Crystal River Nuclear Plant
Docket No. 50-302
Operating License No. DPR-72

Subject: Crystal River Unit 3 – Response to Request for Additional Information to Support NRC Safety Issues Resolution Branch (SSIB) Technical Review of the CR-3 Extended Power Uprate LAR (TAC No. ME6527)

**RESPONSE TO REQUEST FOR ADDITIONAL INFORMATION
– SAFETY ISSUES RESOLUTION BRANCH TECHNICAL
REVIEW OF THE CR-3 EPU LAR**

Figure 1
Proposed Low Pressure Injection System Cross-Tie
and Hot Leg Injection Simplified Diagram

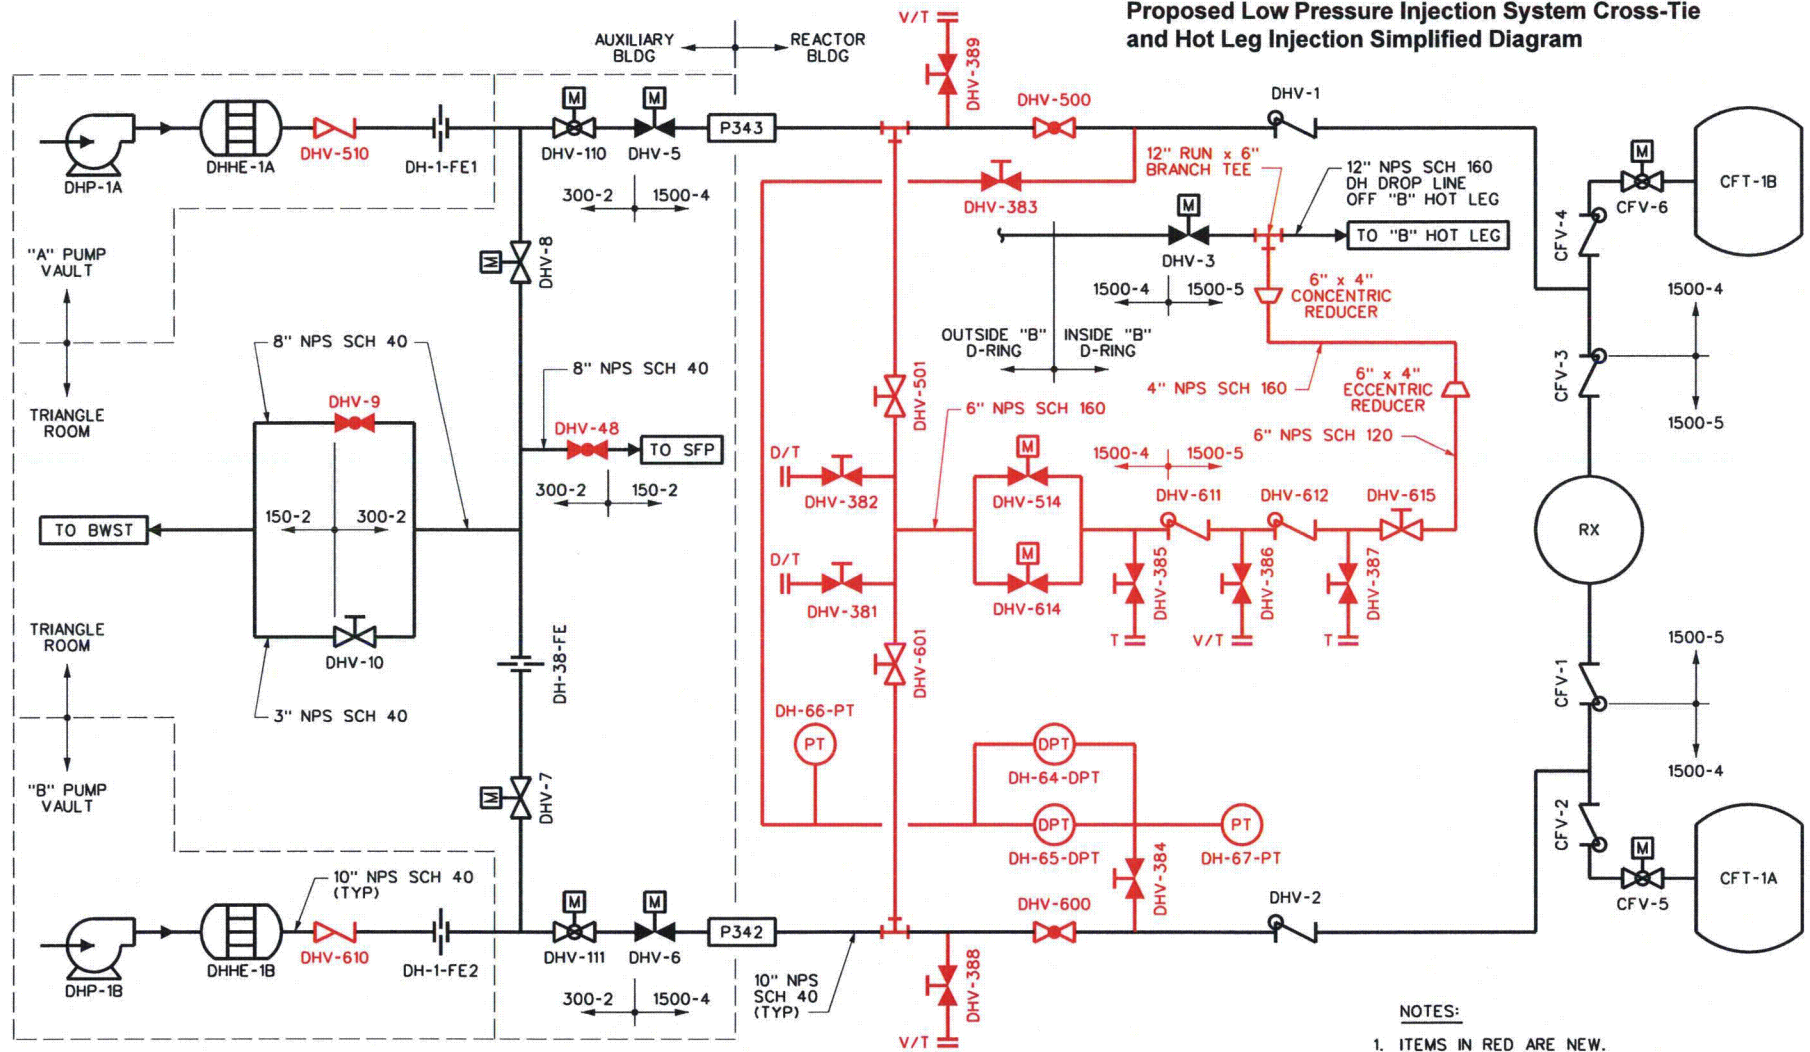
Consistent with the guidance in the NRC staff's safety evaluation on Nuclear Energy Institute [NEI]-04-07, the equipment in the emergency core cooling system (ECCS) and containment spray system, such as pumps and valves, at CR-3 has been evaluated for the effects of debris in the recirculated fluid that bypasses (or passes through) the suction strainers. The power uprate submittal states that valves and piping are being added to the ECCS to support a passive cross-tie between the decay heat removal/low-pressure injection system and reactor cooling system hot-leg B. Please describe the method(s) used to evaluate the new piping system components for blockage and wear and the results of those evaluations.

The new valves for the Low Pressure Injection (LPI) System cross-tie and the hot leg injection (HLI) modification have been assessed for blockage and erosive wear against the wear and plugging criteria of NRC approved topical report WCAP-16406-P-A, "Evaluation of Downstream Sump Debris Effects in Support of GSI-191," (Reference 2). Figure 1, "Proposed Low Pressure Injection System Cross-Tie and Hot Leg Injection Simplified Diagram," illustrates the new valves and instrument sensing lines proposed for installation in the CR-3 LPI System cross-tie and HLI modification.

The new LPI cross-tie modification design includes the following:

- Two Flex Wedge normally open, 10 inch gate valves (DHV-501, 601). The valves provide a full port flow path through the cross-tie line. Plugging and wear impact are not considered critical per Section 8.2, "Valves," of WCAP-16406-P-A.

- Two Y-pattern manual 10 inch globe valves (DHV-500, 600). These manual valves will be locked in a throttled position following flow balancing of the system. It is expected that these valves will be throttled approximately 50% open to establish at least 3000 gpm. FPC has assessed the plugging and wear impact of these valves and concluded that adequate margin exists to account for fine tuning of the valve throttle position during flow balancing. These valves will meet the plugging and wear acceptance criteria of Sections 7.3.3, "Flow Area Evaluation for Plugging and Wear," and 7.3.2, "Erosive Wear," of WCAP-16406-P-A, respectively.

- Two Y-pattern globe style, 10 inch stop check valves (DHV-510, 610). These valves will change position based on pump discharge flow and prevent reverse flow through an idle pump, if necessary. Since these check valves are > 1 inch, and the minimum required flow through the valves is normal LPI System flow (i.e., > 0.42 ft/sec), plugging and wear impact are not considered critical per Section 8.2 of WCAP-16406-P-A.

The new HLI line modification design includes the following:

- Two normally closed motor-operated, parallel slide, 6 inch gate valves (DHV-514, 614). The valves are required to open in certain post-accident scenarios to support boron precipitation mitigation in the core. These gate valves are > 1 inch and are either fully open or fully closed; thus, plugging and wear impact are not considered critical per Section 8.2 of WCAP-16406-P-A.

- One manual normally open, 6 inch Flex Wedge gate valve (DHV-615) provides a full port flow path through the new HLI line. This gate valve is > 1 inch and is normally fully open; thus, plugging and wear impact are not considered critical per Section 8.2 of WCAP-16406-P-A.

- Two normally closed, 6 inch, nozzle check valves (DHV-611, 612) will open to pass process flow in certain post-accident scenarios to support boron precipitation mitigation in the core. Since these check valves are > 1 inch, and the minimum required flow through the valves is 400 gpm (i.e., > 0.42 ft/sec), plugging and wear impact are not considered critical per Section 8.2 of WCAP-16406-P-A.

- Two normally closed, 8 inch, T-pattern, manual globe valves (DHV-9, 48) in the process lines to the spent fuel pool and the borated water storage tank. These normally closed test valves are > 1.5 inches; thus, plugging and wear impact are not considered critical per Section 8.2 of WCAP-16406-P-A.

- The new LPI System pressure instruments (DH-64-DPT, DH-65-DPT, DH-66-PT, and DH-67-PT) utilize 0.5 inch, stainless steel tubing for impulse sensing lines to connect to the LPI System piping downstream of throttle valves DHV-500 and DHV-600. Since the impulse sensing instrument lines are static fluid lines and have no discernible flow, the only credible

method causing the instrument sensing lines to become plugged would be caused by settling debris in the lines. Therefore, the LPI System cross-tie line modification design includes connecting the 0.5 inch sensing line perpendicular to the main 10 inch LPI System piping at the pipe horizontal center-line, which will ensure the sensing lines remain water-solid minimizing the possibility of debris entrapment and settling in the sensing lines. Thus, the LPI System pressure impulse sensing line design meets the criteria specified in Section 8.6.6, "Sensing Line Evaluation," of WCAP-16406-P-A.
